### FREDERICK COUNTY HISTORIC PRESERVATION COMMISSION

## STAFF REPORT

**Address:** 12602 Catoctin Furnace Rd., Thurmont      **Meeting Date:** October 2, 2024  
**Applicant:** Catoctin Furnace Historical Society      **Report Date:** April 15, 2024  
**Case No.:** COA 24-08      **Staff:** Beau Lockard  
**Request:** Replace asphalt shingle roof with standing seam metal roof and reconstruct the brick chimney stack on south elevation.

*Image 1: 1932 image of Catocin Furnace Road, Hoke House on left. Photo taken by Aubrey Bodine.*

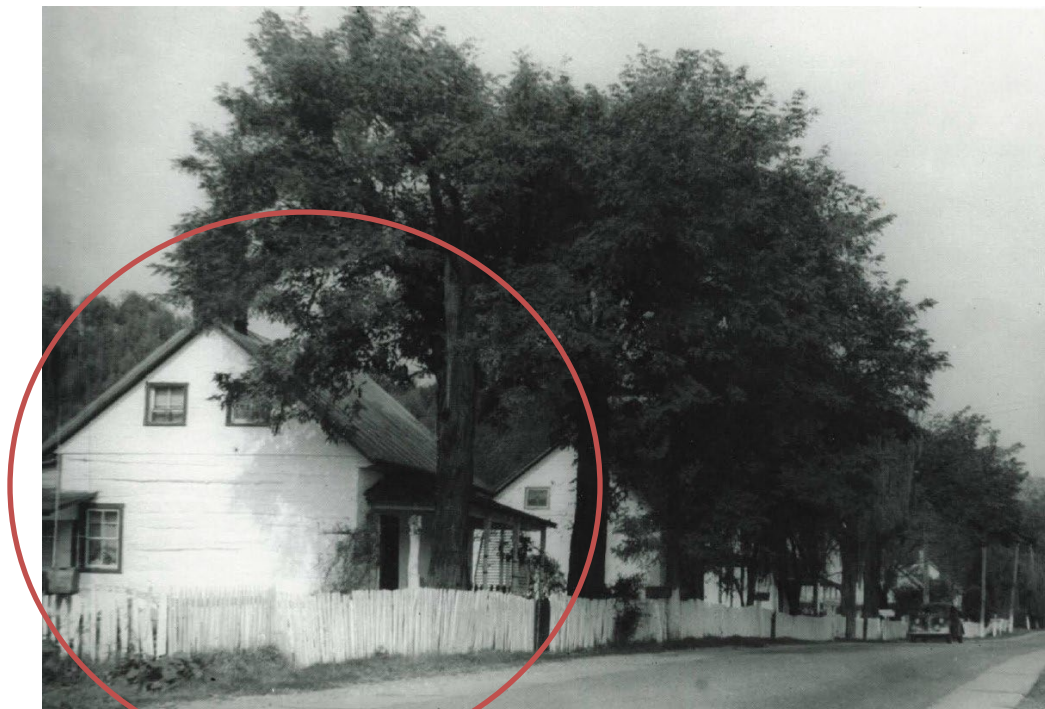
Currently, the historic house has an approximately 30-year-old asphalt shingled roof which has leaking issues. The applicant proposes to replace the current asphalt shingle roof with a hand crimped standing seam metal roof to match the documented historical evidence of a metal roof. The applicant provided an image of the historic house's roof from 1932 that shows a hand-crimped standing seam metal roof (Image 1). This building was constructed ca. 1820s. Asphalt shingle roofs began being used in 1903 and did not grow in popularity until the 1920s. This popularity increase occurred as a part of the National Board of Fire Underwriters' campaign to eliminate wood-shingled roofs.

The roof will be an unpainted 29-gauge galvanized standing seam metal roofing system with 18" wide panels. The proposed work will also protect and rehabilitate the wooden sub roof structure that is currently being damaged by the leaking shingle roof.

*Image 2: 1977 Photograph of the east elevation of the Hoke House with the chimney stack still visible*

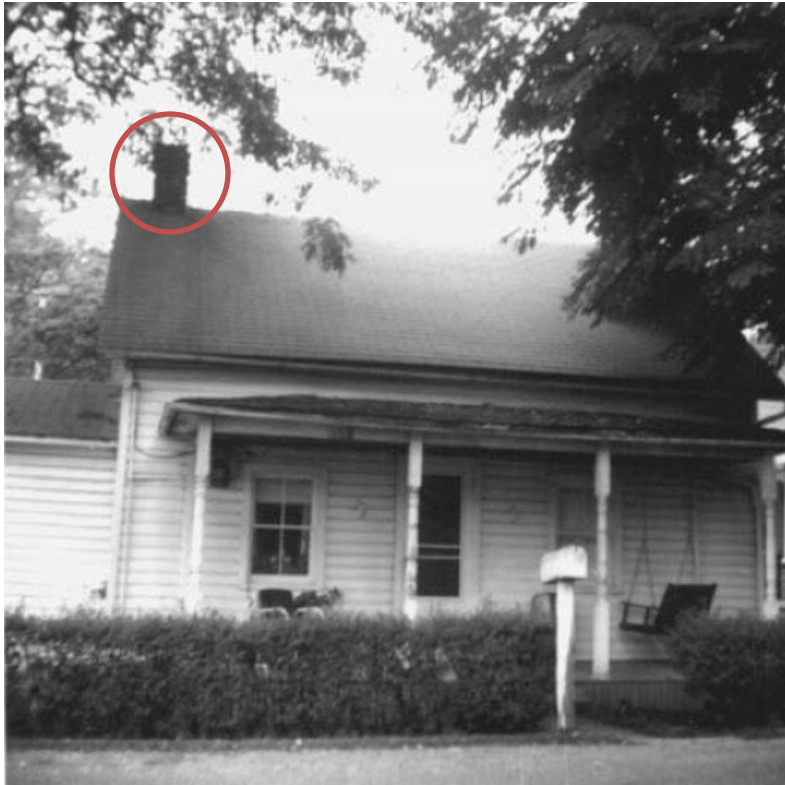
The applicant is also proposing to reconstruct the chimney stack above the roof line on the south elevation, with the location based on historic documentation, including this 1977 photograph below (Image 2). Chimneys are significant characteristics for historic buildings and rebuilding this element will restore the building's historic composition. The applicant will match the new bricks and mortar for the chimney to the extant brick chimneys in the Catoctin Furnace village. The bricks will be Cushwa Glen-Gery 56-DD (Image 3).
